## SB 4-269-001

**SUBJECT: SECONDARY TRANSMISSION SHIFT CONTROLLER**

**MODELS: WX DUAL DRIVE AND WXLL DUAL DRIVE VEHICLES EQUIPPED WITH ALLISON 4th GENERATION TRANSMISSION CONTROLS**

Figure 7

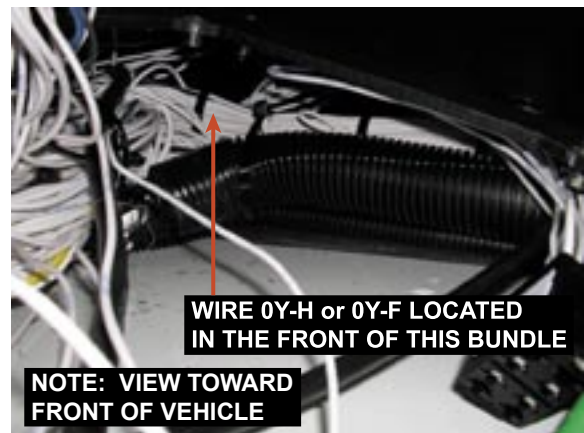
**STEP 2:** Locate wire 0Y-H or 0Y-F, in the front bundle that routes to the Transmission ECU (*Figure 7*). Cut either wire at the most accessible location and strip both ends.

*Figure 8*

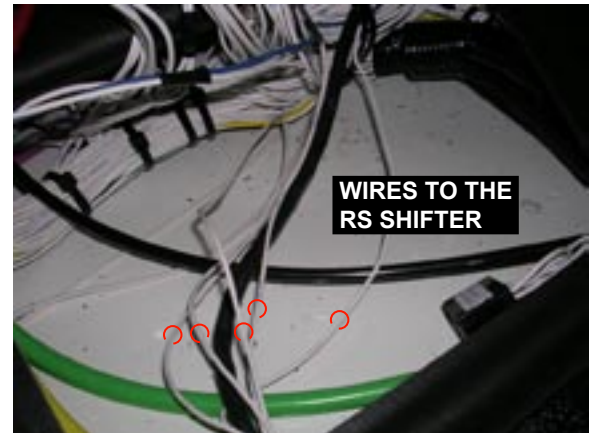
**STEP 3:** Locate splice 11 (SPL-11). It will be located in the branch leading to the right side shifter (*Figure 8*). Locate wire 0C on the left side of this splice. Follow wire 0C as far to the front of the vehicle as possible. Cut wire 0C at this location and tape off the end that leads to the main cab harness. On the remaining leg of wire 0C (leading back to SPL-11), strip the end of the wire.

**STEP 4:** Create a new splice with solder and heat shrink tubing or electrical tape, connecting both ends of the 0Y-H or 0Y-F wire to the stripped end of wire 0C leading to SPL-11. A 16-14 or 12-10 gauge butt splice will be required.
